**81141A-01-S**

**S E R V I C E N O T E**

**Product Number: 81141A, High Speed Pulse Generator**

**POSSIBLE FIRE HAZARD**

**Polypropylene Molding****Start of Fire****Graphics Card**

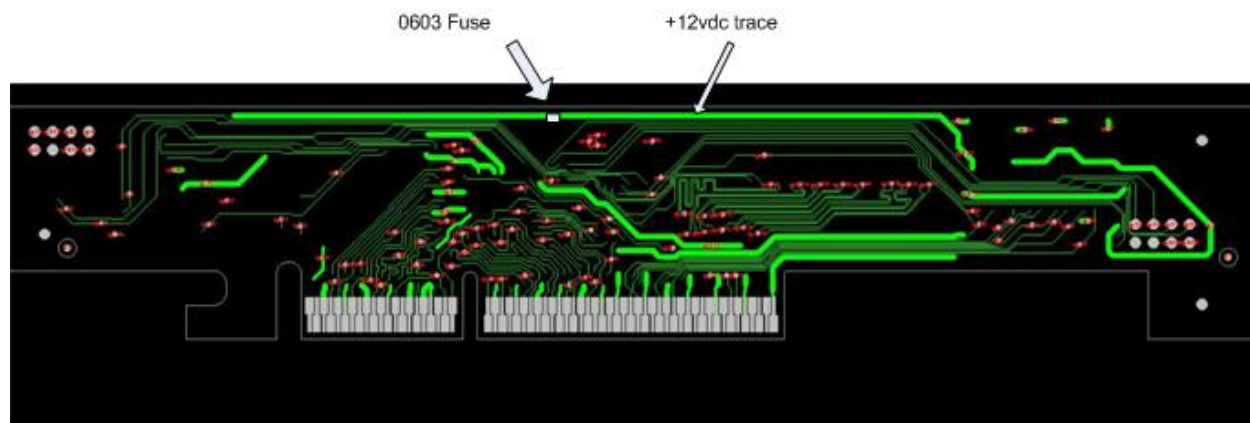
A surface-mount ceramic capacitor suffered physical stress during the manufacturing process, leading the capacitor to crack. During operation this crack placed stress on the internal structure of the capacitor, and caused the plates to short together. (The plates are separated by very little space, made up of very thin insulators.) This caused the capacitor to have very low residual impedance, resulting in a very high current conducted through the capacitor and the 12V path on the motherboard for some period of time. The low impedance didn't lead to a current high enough for blowing the fuse. Therefore the higher current was available long enough to create a very high temperature ( $T > 300^{\circ}\text{C}$ ). The high temperature ignited the polyurethane molding used to conduct the airflow for cooling through the instrument.

The following photo illustrates the layout of the instrument. It shows the polypropylene molding, the graphics card and the starting point of the fire.

The countermeasure for this issue is to exchange the graphics cards. The new graphics cards are produced with an improved manufacturing process eliminating the risk of micro cracks and have additional fusing to protect the 12V path. The graphics card can be exchanged by Agilent authorized personnel only.
